Addendum 02

PROJECT: Arcanum-Butler Local Schools Booster Stadium Phase 3
310 North Main Street
Arcanum, Ohio 45304

PROJECT #: 23047.03

This addendum form is a part of the Contract Documents and modifies the Construction Documents dated January 6, 2026, with amendments and additions noted below.

SHEET NUMBER:
GO.1

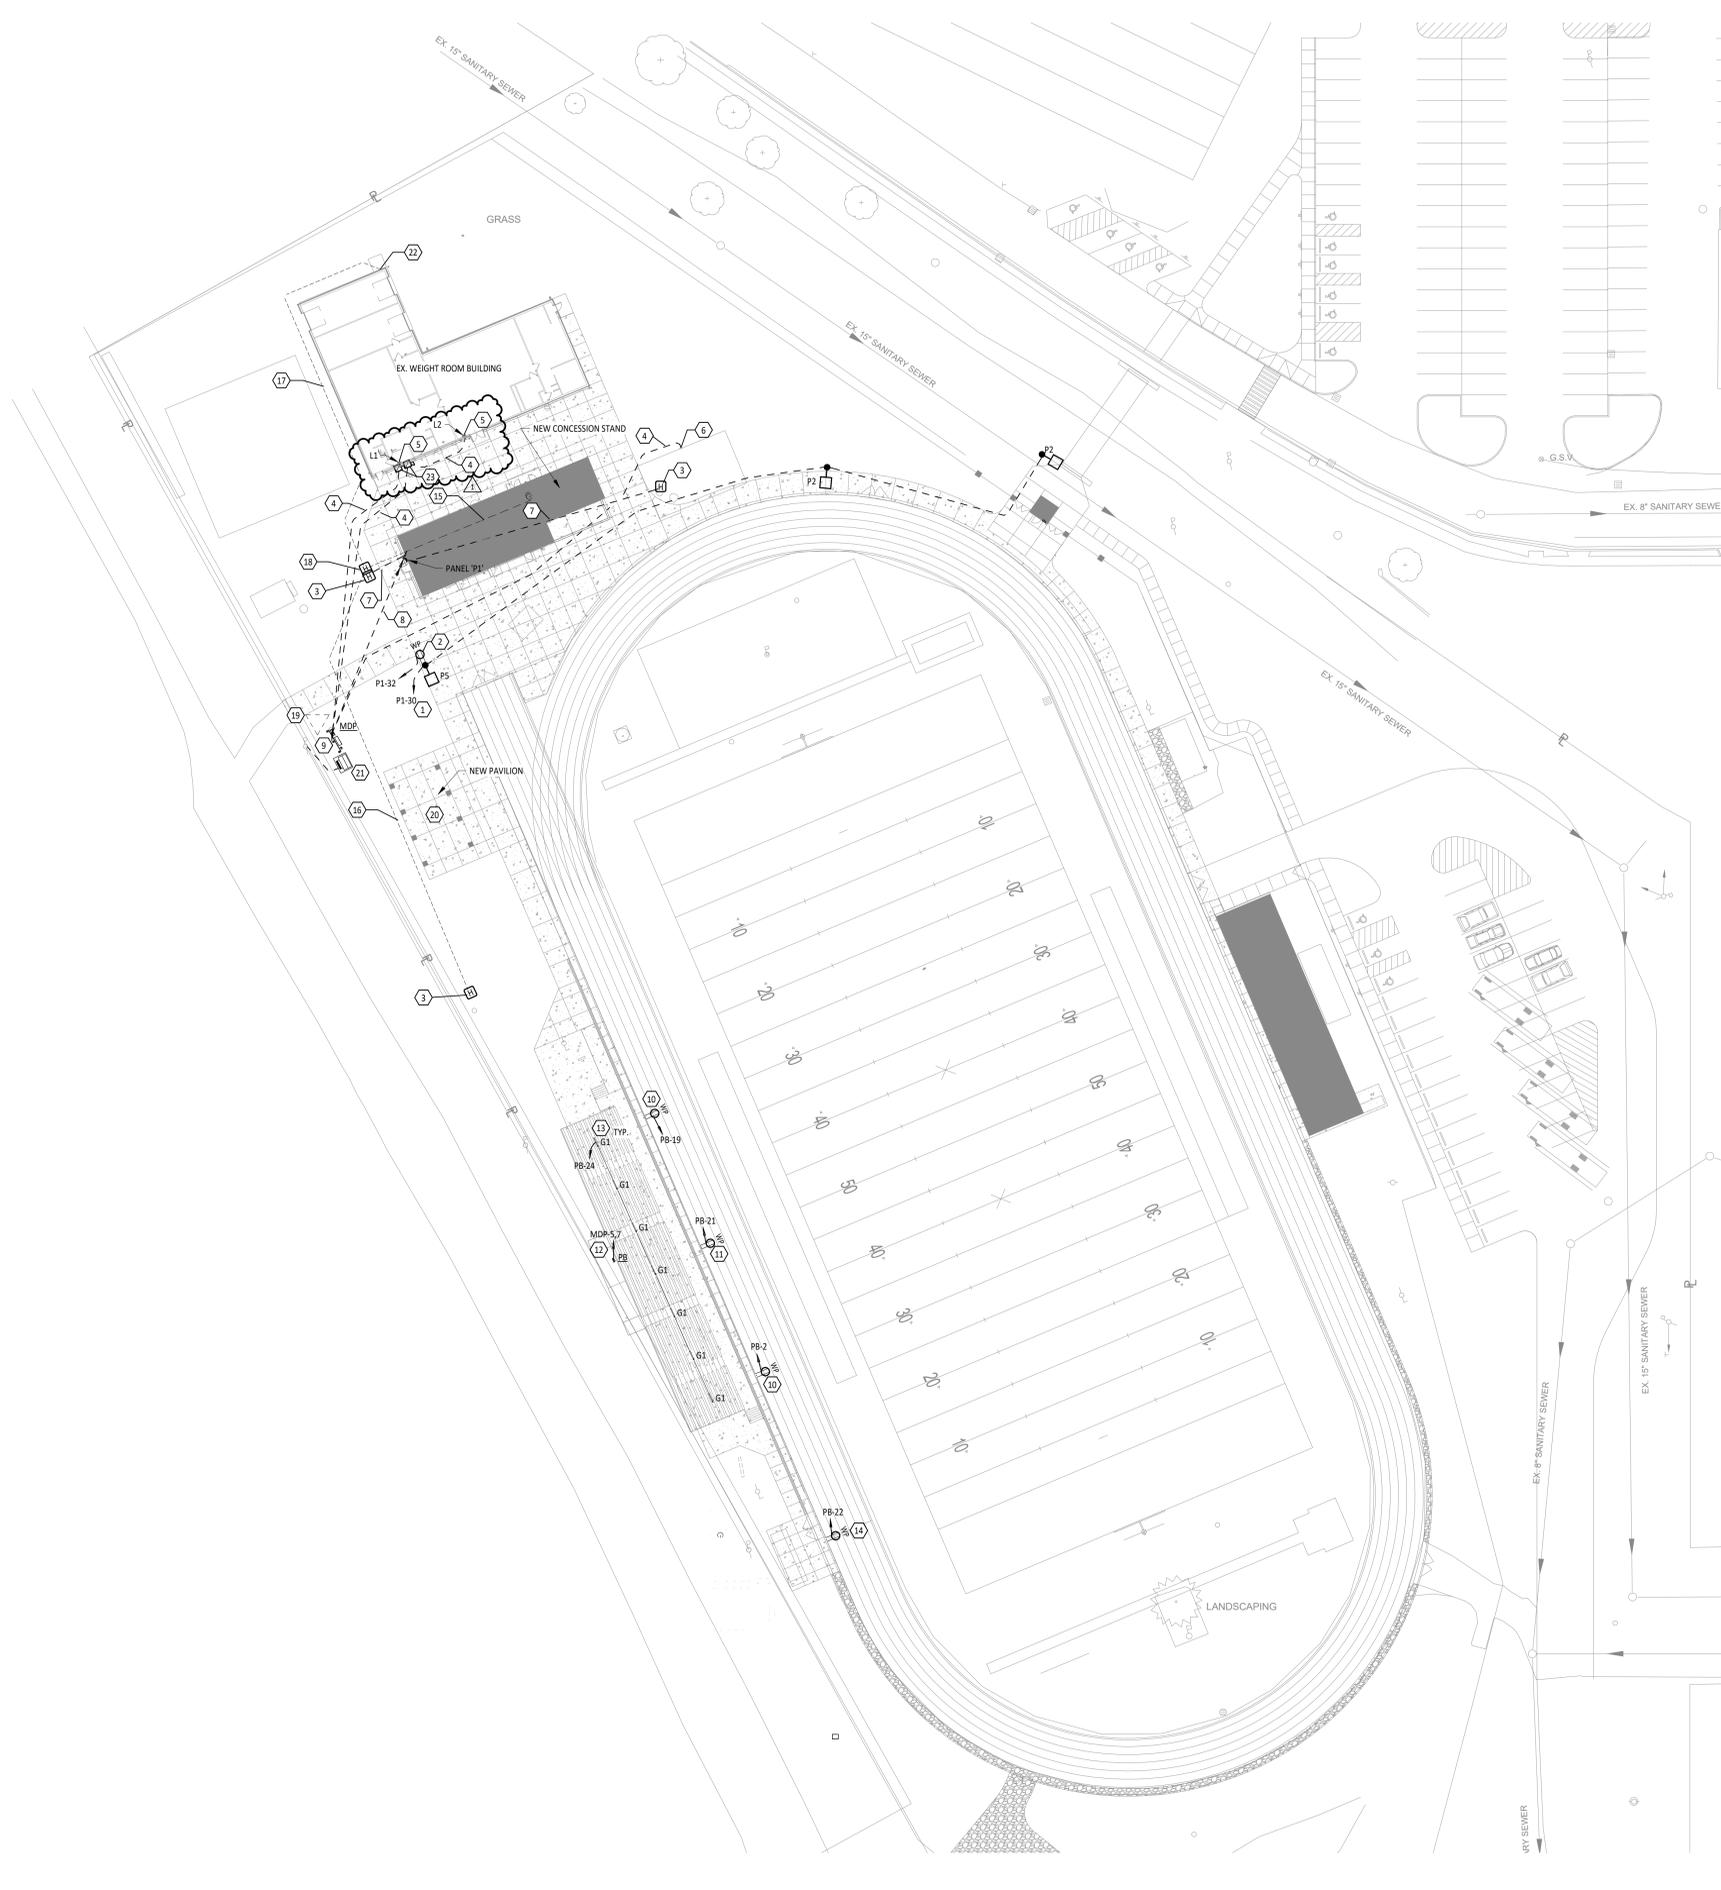
1. Drawing sheet G0.1 Cover Sheet and Code Plan
 - a. Code information updated for A3 occupancy. Maximum allowable area for A3 occupancy is 6,000 SF.
2. Drawing sheet E2.1, Site Electrical Plan:
 - a. The existing weight room building has been shifted on the plans.
 - b. Add two (2) 200A, 120/240V, 1-Phase, 3-Wire, Fused, NEMA 3R disconnects to the exterior of the existing weight room building, disconnects shall be utilized to feed the two existing weight room panels.
3. Drawing sheet E8.1, Electrical One-Line Diagrams and Panel Schedules: Add two (2) 200A, 120/240V, 1-Phase, 3-Wire, Fused, NEMA 3R disconnects to the exterior of the existing weight room building, disconnects shall be utilized to feed the two existing weight room panels.

CONCESSION/RESTROOM/STORAGE BUILDING	
OCCUPANCY / USE GROUP:	A-3
CONSTRUCTION TYPE:	TYPE V-B
ALLOWABLE AREA (TABLE 506.2):	6,000 SF
AUTOMATIC SPRINKLER AREA INCREASE (TABLE 506.3) (200%):	NOT APPLICABLE
BUILDING FRONTAGE AREA INCREASE (TABLE 506.3):	6,000 SF
ACTUAL BUILDING AREA:	SEE SCHEDULE
